1 ELWOOD

HPACD DESIGN REVIEW 2

10/24/2024

09/26/24 Feedback on Proposed Building

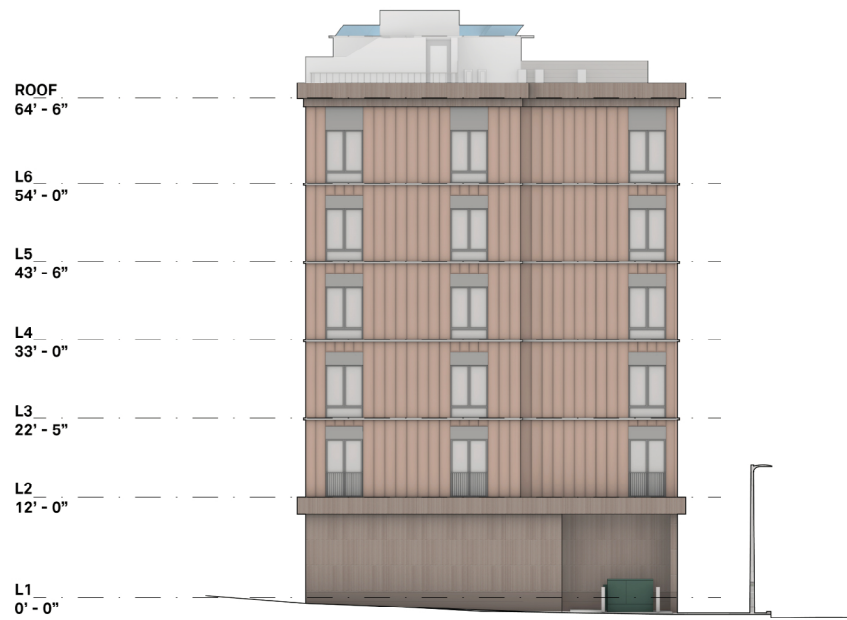
- The proposal creates a **notion of the gateway** to the residential neighborhood by mitigating the perceived scale of the neighborhood.
- In terms of design, explore ways to **enlarge the windows and add depth**. Reconsider the **corbeling design** on each floor and the **vertical expression of the terracotta**.
